FAQ 22-03: Susquehanna Scram – Proposed Response

Plant: Susquehanna Steam Electric Station Unit 2

Performance Indicator: **Unplanned Scrams with Complications**

Figure 1: Reactor Pressure Control

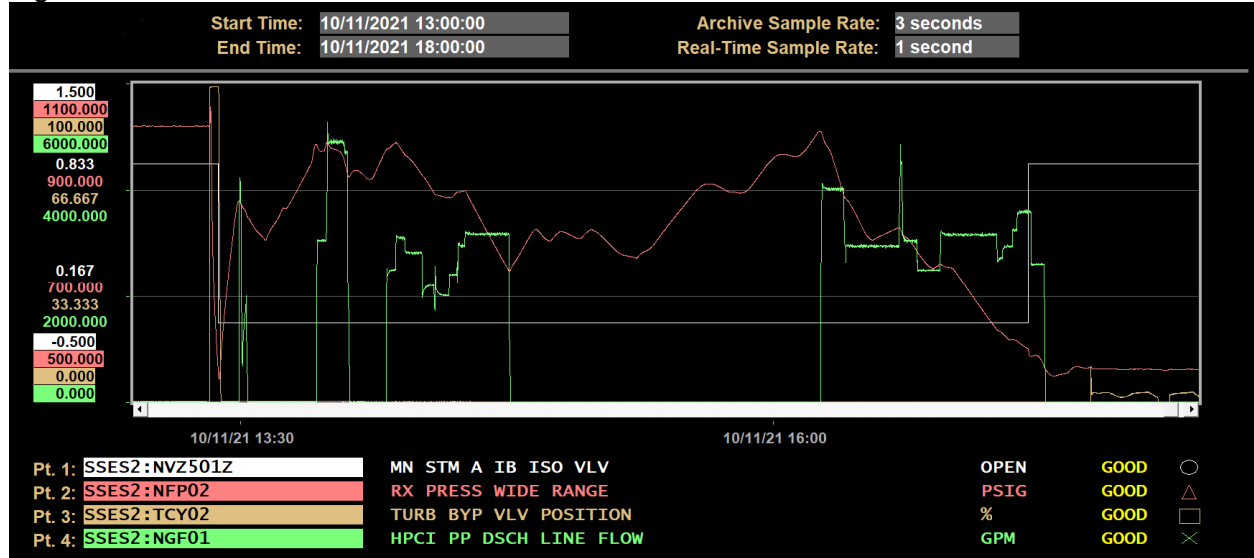
The initiating event for the scram was a Turbine Generator trip from 94.7% power which caused a reactor scram. All turbine bypass valves (TBV) immediately opened, completing their safety function. Three (3) Safety Relief Valves (SRVs) (of the 16 SRVs) opened to help mitigate the reactor pressure rise, as expected. Reactor pressure peaked and turned downward and the open SRVs closed. All control rods inserted as expected during the scram. As reactor pressure lowered, the ‘B’ Electro-Hydraulic Control (EHC) pressure regulator stuck which held all bypass valves open. This resulted in reactor pressure continuing to reduce rapidly and Operators taking manual action to close the Main Steam Isolation Valves (MSIVs). Following the initial transient, operators established pressure control in accordance with EO-000-102, RPV Control, which is entered as part of a normal scram response. Approximately eight (8) minutes following the reactor scram, pressure control was established using Main Steam Line Drains with reactor pressure at ~880 psig. This did not require using any procedures beyond the normal scram response. Approximately 30 minutes following the reactor scram, High Pressure Coolant Injection (HPCI) was placed into pressure control mode at ~950 psig to support pressure control while maintaining steady RPV level control. The scram response procedure, EO-000-102, RPV

Control, was also used by Operators to place Reactor Core Isolation Cooling (RCIC) in service to control Reactor Pressure Vessel (RPV) level. Subsequent to the MSIV closure, the Turbine Bypass Valves automatically closed. Later in the scram response, the MSIVs were re-opened and pressure control was transferred to the Turbine Bypass Valves. Figure 1 below is provided for reference to key parameter response during the event.

The initiating event for the scram was a Turbine Generator trip from 94.7% power which caused a reactor scram. All turbine bypass valves (TBV) immediately opened. Three (3) Safety Relief Valves (SRVs) (of the 16 SRVs) opened to help mitigate the reactor pressure rise, as expected. Reactor pressure peaked and turned downward and the open SRVs closed. All control rods inserted. As reactor pressure lowered, the station determined the ‘B’ Electro-Hydraulic Control (EHC) pressure regulator was stuck which held all bypass valves open. This resulted in reactor pressure continuing to reduce rapidly and operators taking manual action to close the Main Steam Isolation Valves (MSIVs) to stop the rapid pressure reduction.

During an uncomplicated scram where there is no failure of the pressure control system (i.e., turbine bypass valves), the EHC pressure regulator would normally establish reactor pressure at approximately 800 psig which would end the initial transient. Since there was a failure of the pressure regulator in the EHC system, reactor pressure continued to decrease below 800 psig, which was beyond the pressure expected for the initial transient. Operators recognized that the pressure control system (i.e., turbine bypass valves) was not functioning and closed the MSIVs per station procedures.

It is correct that additional SRV cycling was not required post-scram. Due to the initial failure of the turbine bypass valves, which resulted in pressure lowering to approximately 550 psig,

Based on the guidance of NEI 99-02, Revision 7 the NRC Staff concluded that the question "Was pressure control unable to be established following the initial transient?" should be answered "No." Following the initial transient, despite an EHC failure, pressure control was able to be established using the Main Steam Line Drains and the High Pressure Coolant Injection (HPCI) in pressure mode as part of the pressure control system. Pressure was established without the automatic cycling of SRV(s) and without having failed open SRV(s). Therefore, this event should not be classified as an Unplanned Scram with Complications.

It is the NRC staff’s position that for the Susquehanna Unit 2 scram on October 11, 2021, reactor pressure was successfully controlled following the initial transient by using Main Steam Line Drains to the condenser and HPCI in pressure mode. It was acknowledged that a failure of the ‘B’ Electro-Hydraulic Control (EHC) pressure regulator occurred, resulting in a reduction in pressure and the operators taking manual action to close the Main Steam Isolation Valves (MSIVs). The EHC pressure regulator would normally control pressure, however HPCI in pressure mode is also identified as part of the “pressure control” system in NEI 99-02 Revision 7 and an acceptable means to maintain pressure.
